CPED STAFF REPORT

CPC Agenda Item #3
April 27, 2015
BZZ-7062 and Vac -1641

Property Location: 420 East Hennepin
Project Name: 420 East Hennepin
Prepared By: Aaron Hanauer, Senior City Planner, (612) 673-2494
Applicant: Mark Krogh, Java Companies
Project Contact: Nathaniel Shea, Tanek
Request: To construct a one-story, approximately 5,100 square foot commercial building
Required Applications:

SITE PLAN

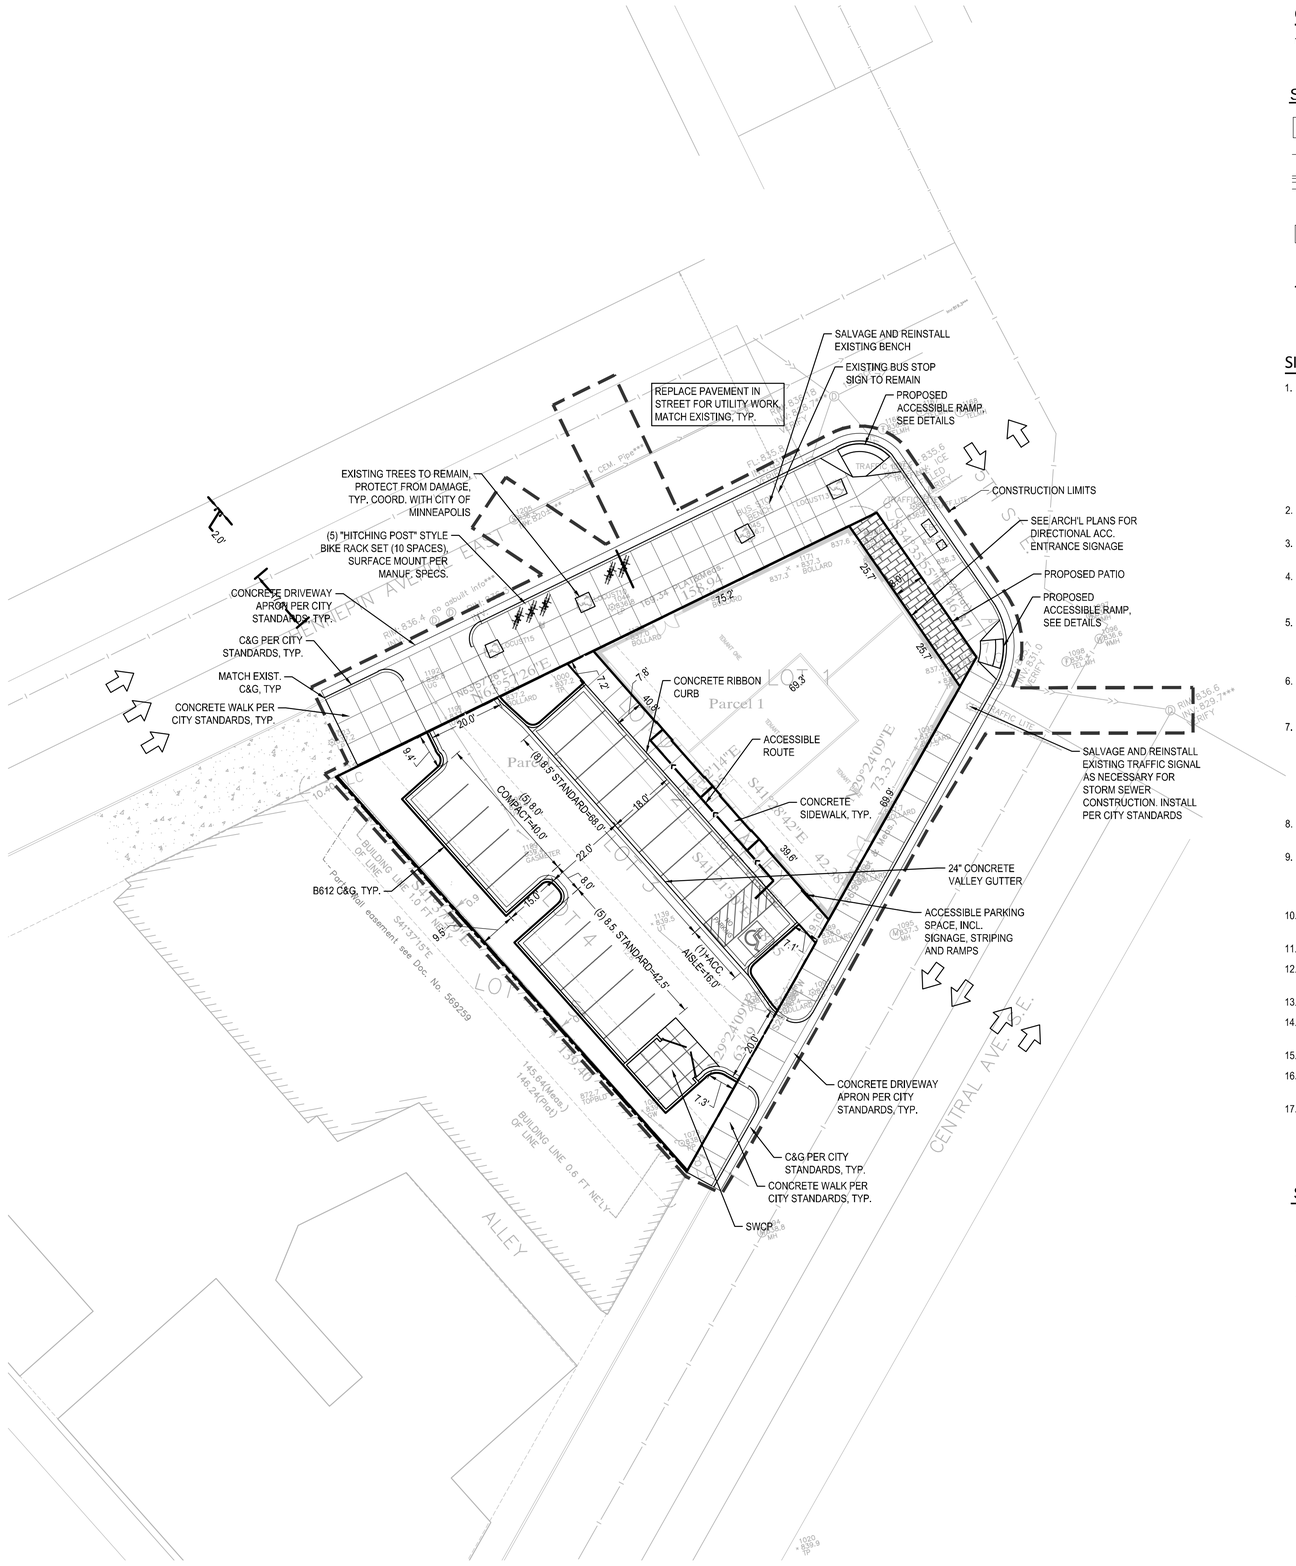
- At a minimum site plan review application will be required for the proposed new construction.
- Applicant is proposing 16 percent landscaping which is below the minimum 20 percent required:

- a second tree will be required along Central Avenue NE to comply with the site plan review requirement: "Not less than one (1) tree shall be provided for each twenty-five (25) linear feet or fraction thereof of parking or loading area lot frontage."

- Will likely require a main entrance along 5th Street SE to comply with site plan review standard: "The building shall be oriented so that at least one (1) principal entrance faces the public street. In the case of a corner lot, the principal entrance shall face the front lot line."

- Proposing pavement foxi rose for screening of the parking lot along Central Avenue NE and Hennepin Avenue Northeast. Provide documentation that shrub planting will meet the requirement of being three feet in height and not less than 60 percent opaque year around.

- All Metro Transit Bus stops shall be clearly identified on the plans.
- Current ordinance states that all maneuvers associated with loading, parking or sanitation pick up for a private development shall occur on private property. Please provide a narrative explaining the trash removal operations and show turning maneuvers for all truck type vehicles that will be using the site and loading/parking entrance areas. Per City Ordinance the Applicant shall provide for (and identify) a solid waste collection point (SWCP) on the site plans. The location of the SWCP is subject to the review and approval of the Public Works Department.

- Each parking space should have turning maneuvers that can be done without crossing the right of way for each direction the vehicle could be traveling in. Show the turning maneuvers for the two end spaces on the westerly most parking lane.

- Please contact Bill Prince at (612) 673-3901 regarding existing and proposed street lighting. All street lighting (existing and proposed) shall be shown clearly on the site plan.

- Submit section view drawing of proposed concrete ribbon curb.
- Clearly identify accessible entrance doors for both restaurants and must comply with 2015 Minnesota State Accessibility Code Section 402.2.1. Minimum 5' x 5' landing at accessible entrance doors and it must be noted on site plan.

- Install new direction signage on entrance doors on 5 Street East, directing public to ADA Compliance doors and ADA Parking Area.
- Submit SAC Determination Letter when submitting construction plans for review.
